CONTRACT CHANGE ORDER NO. 228 S2

MARK	DATE	DESCRIPTIONS	BY	CH'D	CCO#
3	04/03/13	BIKEPATH LEVELING (PP103-HINGE A)	AB	TH	228S2
2	03/15/13	BIKEPATH DETAILS	DT	MN	303
1	12/14/12	BIKEPATH DETAILS	DT	MN	99S1
0	03/04/11	BIKEPATH DETAILS	RB	TH	99

SAN FRANCISCO OAKLAND BAY BRIDGE
EAST SPAN SEISMIC SAFETY PROJECT
SELF-ANCHORED SUSPENSION BRIDGE (SUPERSTRUCTURE & TOWER)

BIKEPATH DETAILS NO. 22

ALTERNATE PARTIAL PLAN AT PP128

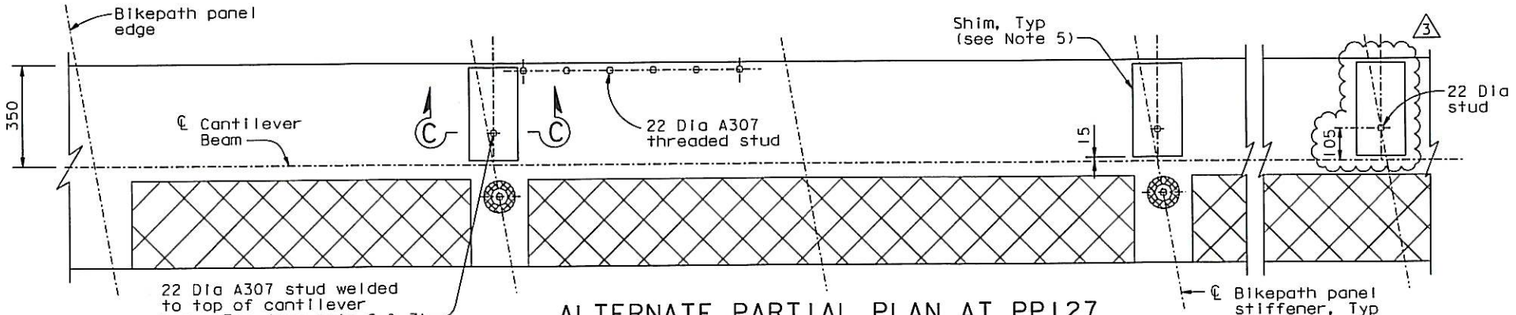
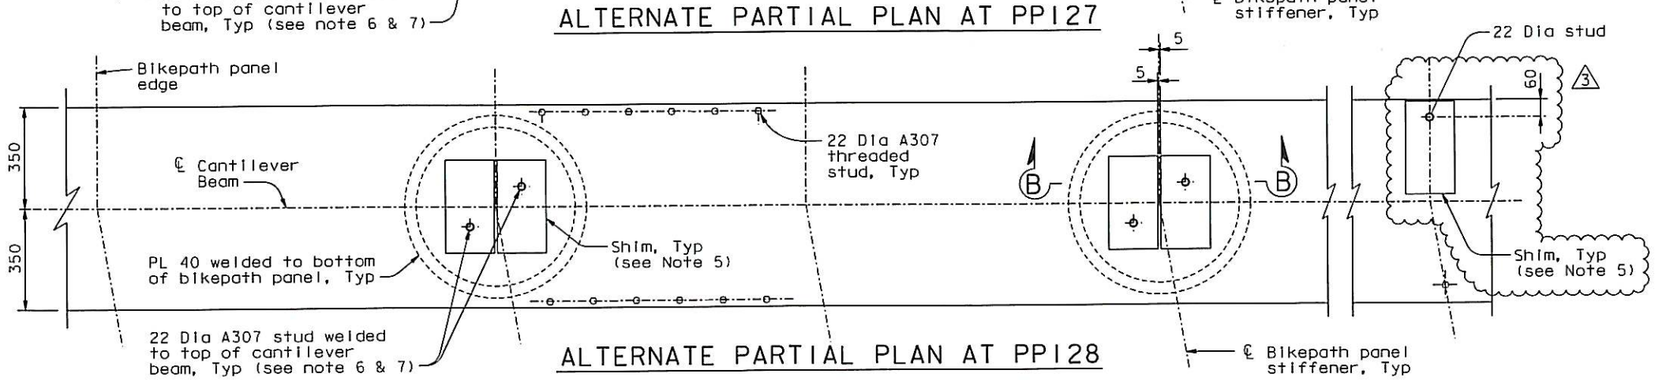
1. Before application of overlay, pipe 25X to be cut off and ground flush with bikepath panel top PL.
2. Seal PL 6 is used to cover holes in bikepath panel top PL. At the Contractor's option, an alternate sealing detail for the grout tube may be proposed for review and approval of the Engineer.
3. At the Contractor's option, shim heights may be detailed per Details G & J on "Bikepath Details No.19" sheet.
4. Grout will be injected in the following cases:
   - If it cannot be determined if the panel is bearing on the ring shims.
   - If welding an additional shim is not practical due to its thickness.

Prior to grouting, the Contractor shall submit grout specifications for review and approval of the Engineer.
5. For steel-reinforced elastomeric shim details, see "Bikepath Details No.23" sheet.
6. Height of stud is equal to the steel reinforced elastomeric shim thickness minus 10 ±3 mm.
7. At the Contractor's option, Grade C1015 may be used, subject to review and approval of the Engineer.

SHIM DETAIL (Bikepath Panel Not Shown)
1:5
(PP127 & 128 Similar) ⚠1

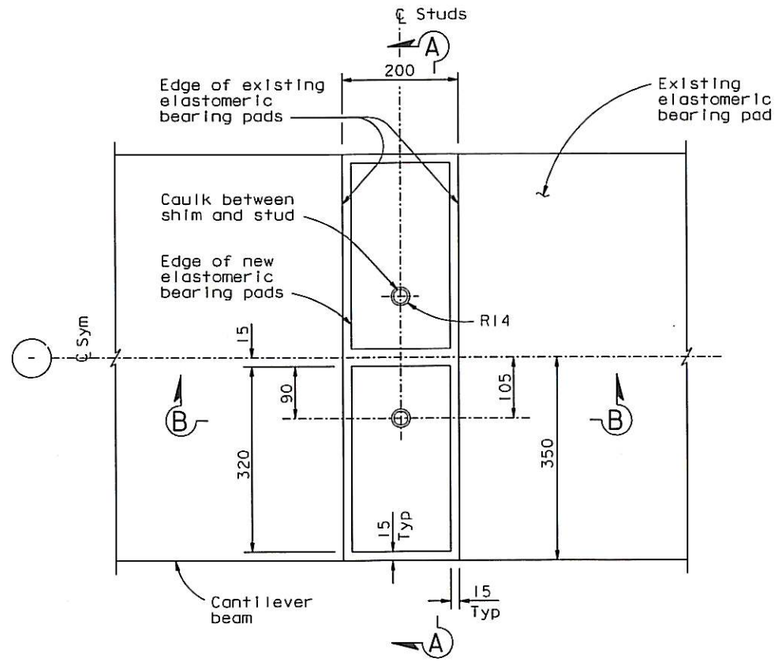
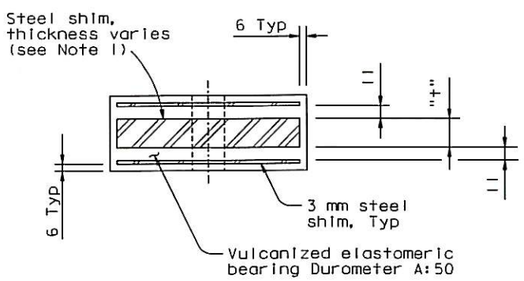
1. For steel shim thickness "t", see "Bikepath Details No. 24" sheet.
2. ⚠1 Dimension to center of hole shall be 55 for one shim on PP128. See "Bikepath Details No. 22" sheet.
3. From PP109 to Hinge A, prior installation of elastomeric 25 bearing pad on "Bikepath Details No. 4" sheet is not necessary.
